Access Compliance Report Public Rights-of-Way (Curb Ramps)

Main Street: BOSTONIAN_DR Cross Street: BOSTONIAN_DR Location: SW

ADA ID: RPRK211215132927 Ramp Type: Type 1 - Perpendicular Initial Pass/Fail: Fail Overall Compliance: No Severity Score: 16

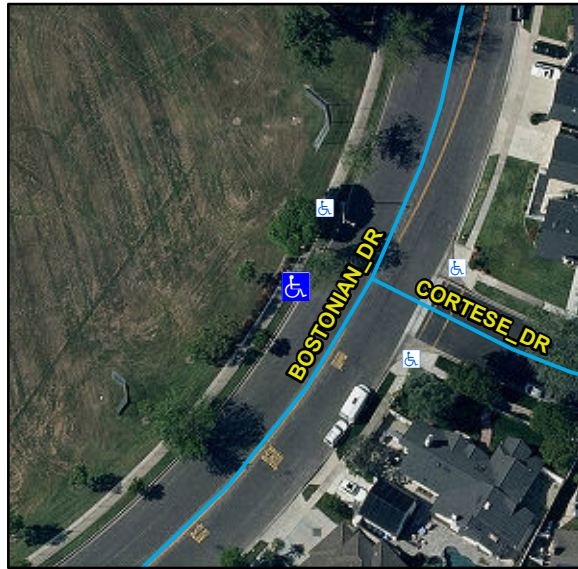
Compliance	Description	Data	Compliance	Description	Data
N/A	Ramp Length (in)	58	N/A	Flare Type LT	
Yes	Ramp Width (in)	48			N/A
No	Ramp Run Slope (%)	8.4	N/A	Flare Slope LT (%)	N/A
Yes	Ramp Cross Slope (%)	1.5	N/A	Flare Traversable LT	N/A
N/A	Landing Present	N/A	N/A	Flare Type RT	
N/A	Landing Length (in)	N/A			N/A
N/A	Landing Width (in)	N/A	N/A	Flare Slope RT (%)	N/A
N/A	Landing Run Slope (%)	N/A	N/A	Flare Traversable RT	N/A
N/A	Landing Cross Slope (%)	N/A	N/A	DWS Provided	N/A
N/A	Landing Movement Obstructed?	N/A	N/A	DWS Contrast	N/A
	Landing Movement Type	N/A	N/A	DWS Length (in)	N/A
N/A	Landing Shared	N/A	N/A	DWS Full Width	N/A
N/A	Clear Space	N/A	N/A	DWS Offset Left (in)	N/A
N/A	Clear Space To Crosswalk (in)	N/A	N/A	DWS Offset Right (in)	N/A
N/A	Marked Crosswalk 1	No	N/A	Marked Crosswalk 2	N/A
	Crossing 1 Direction	SE		Crossing 2 Direction	N/A
	Marked Crosswalk 1 Width (in)	N/A		Marked Crosswalk 2 Width (in)	N/A

N/A	Ramp Inside Crosswalk 1	N/A	Yes	Ramp Inside Crosswalk 2	N/A
	Crossing 1 Slope (%)	7.9		Crossing 2 Slope (%)	N/A
	Crossing 1 Cross Slope (%)	0		Crossing 2 Cross Slope (%)	N/A
N/A	Gutter Ponding	N/A	No	Curb Slope	9.2
Yes	Gutter Lip Height (in)	0		Road Run Slope (%)	N/A
N/A	Gutter Run Slope (%)	N/A		Road Cross Slope (%)	N/A
N/A	Gutter Cross Slope (%)	N/A			
Yes	Overall Surface Condition: Acceptable		No	Perp Joint Present	No
	Cross Gutter Present?	No		Spandrel Present?	No
	Replace Cross Gutter?	N/A		Replace Spandrel?	N/A

Remove & Replace Entire Ramp.

R304.2.2, R204.3, STD 1115
